Interactive comment on “Socio-hydrologic perspectives of the co-evolution of humans and water in the Tarim River Basin, Western China: the Taiji–Tire Model” by Y. Liu et al.

Received and published: 26 January 2014

Fig. 1.

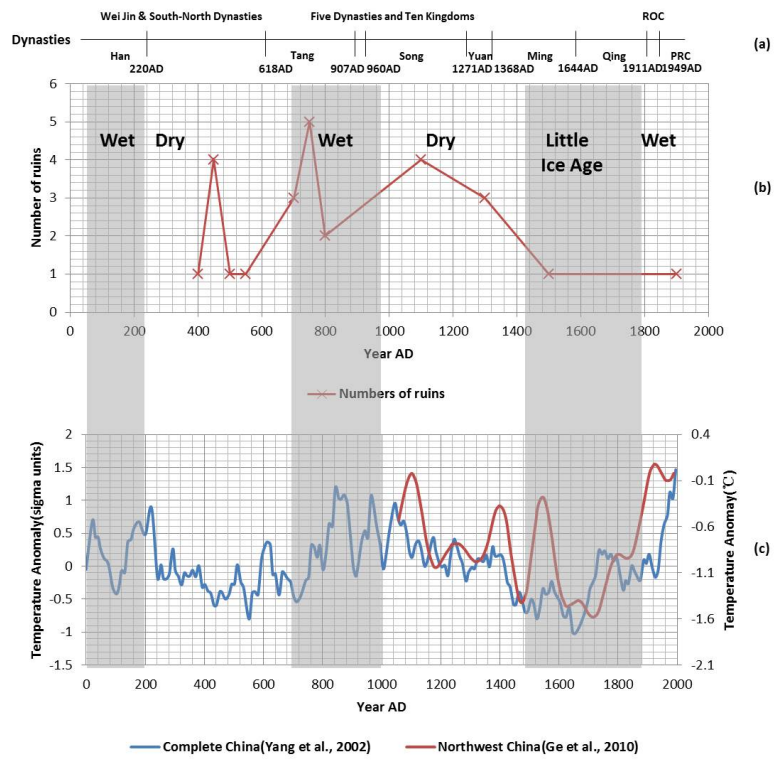
10. In Figure 4c, it is not clear that the association of the two lines and the vertical axes.

Answer: We have updated the Fig. 4c with correcting mis-spelled word “anomaly” and clearly labelling the vertical axes with the two lines. Thanks. Please note that after we moved the Taiji-Tire part earlier as Sect. 3, the previous Fig. 4 is now Fig. 5 in revised manuscript.
